CLARK COUNTY, NEVADA
BID NO. 603795-15
CIRCUS CIRCUS DRIVE FROM INDUSTRIAL ROAD TO
LAS VEGAS BOULEVARD

November 3, 2015

ADDENDUM NO. 2

TYPICAL LIMITS OF INTERSECTION DETAIL
(N.T.S)

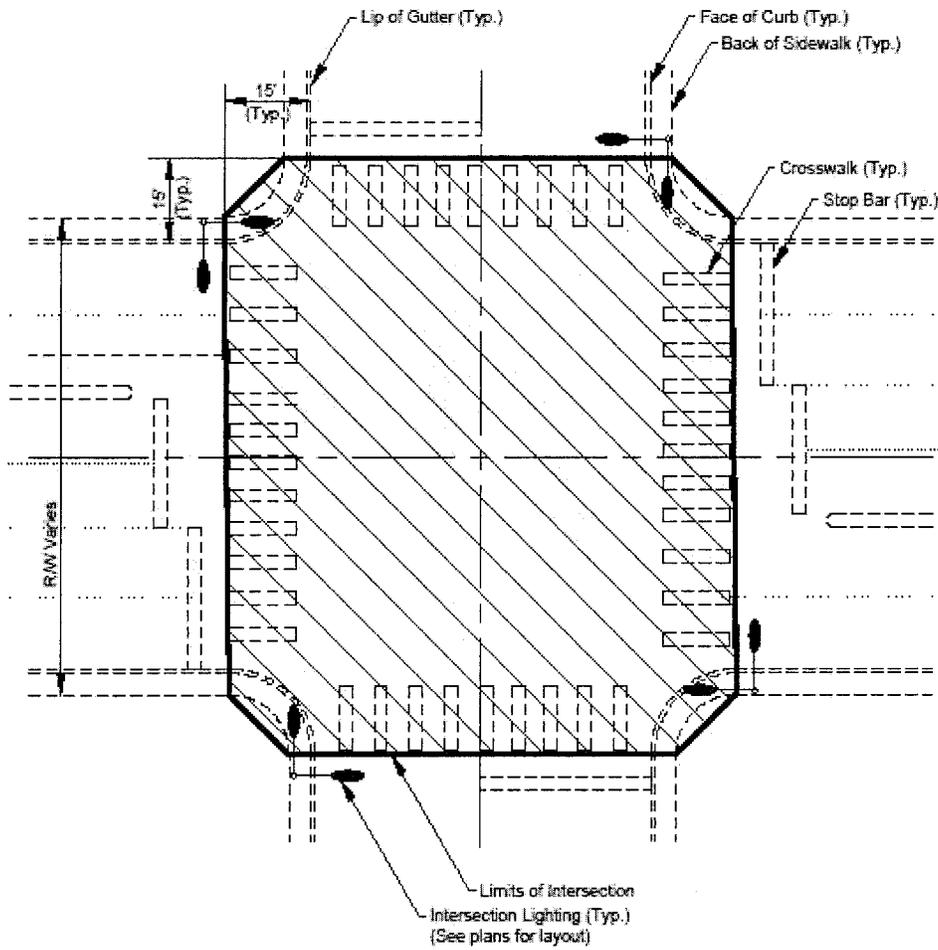
8. Fixtures installed for typical intersection lighting for an intersection shall achieve average maintained illumination as outlined in IESNA RP-8-14, Table 8 (Major/Major, High and E_{avg}/E_{min}) within the limits of the intersection (see Limits of Intersection detail). Lighting luminaire arms are 15 ft in length, with fixtures at the mounting height of 30 or 37 ft. Supplier must provide an illuminance study for both 30-ft and 37-ft luminaire mounting heights, that proves that lighting luminaire standards are met or exceeded per IESNA RP-8-14, with a light loss factor of 0.94.
